# **Staff Report**

# Infill Housing Design Review Committee

File Number: 6-C-24-IH

Location: 112 - 114 Warren Ave. Parcel ID 81 K M 034

FRONT ELEVATION

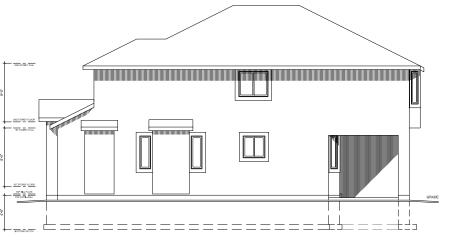
- 4. The duplex's façade, at 30' wide, is comparable in scale and width to other houses in the broader neighborhood. The foundation height is depicted as a slab on grade; the applicant should clarify the visible foundation height and the foundation should be at least 12" to be compatible with historic houses in the neighborhood.

- 6. Guidelines recommend that windows and door styles are similar to historic houses on the block, with similar proportions and positions, and similar ratio of solid to void. The large, round-arched windows on the facade are not compatible with the historic context of the neighborhood, where houses typically have double-hung windows. Façade windows should be revised to meet design guidelines.

Staff recommends approval of Certificate 6-C-24-IH, subject to the following conditions: 1) final site plan to meet City Engineering standards; 2) revisions to façade windows to incorporate double-hung windows or other window styles compatible with the guidelines.
